PROTERRA

TECHNICAL SERVICE BULLETIN

DOCUMENT CREATION DATE:	5/28/2019
SERVICE CAMPAIGN SUBJECT:	Catalyst 40 Clamshell Bracket Retrofit
VINs or MODELS AFFECTED:	Service Specified Buses
SERVICE CAMPAIGN #:	SC-19-72

CATALYST 40 CLAMSHELL BRACKET RETROFIT

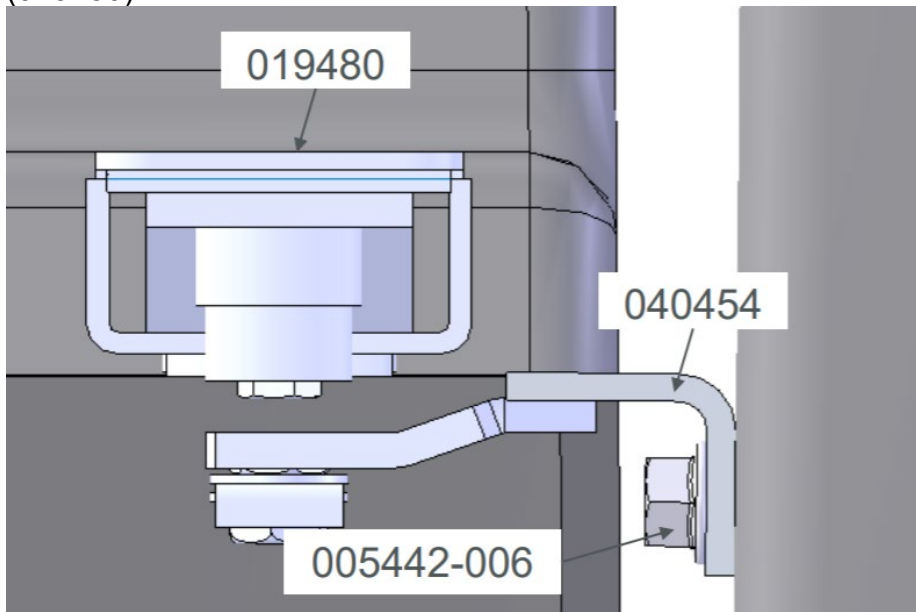
4. Using a 10mm Ratchet/Socket and a 10mm Combination Wrench, remove the three existing Catches shown in blue from the bus.

5. Using a 10mm Ratchet/Socket and a 10mm Combination Wrench, install the three new Catches (040454) using new Bolts (005442-006) and new Nuts (005448) from the kit.
6. Using a Calibrated Torque Wrench with a 10mm Socket, **torque the nuts (005422-006) to 8 Foot Pounds.**
7. Using a 10mm Ratchet/Socket, remove the existing latches.

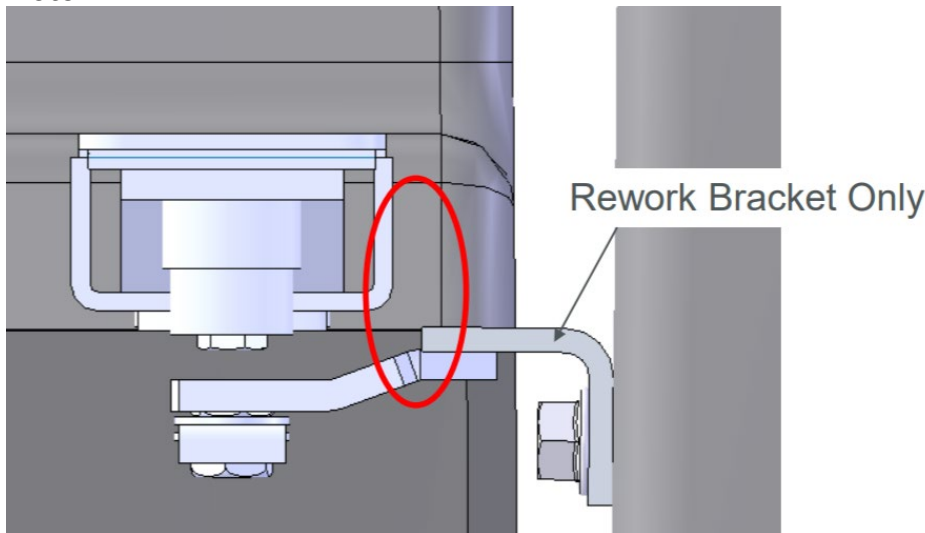
- Using a 10mm Ratchet/Socket, replace the three existing latches with the new Latches (019480) from the kit.

- Verify that the new brackets do not interfere with the new latches. If interference occurs, use a grinder to remove material from the bracket.
Note: Do not remove material from the latch.
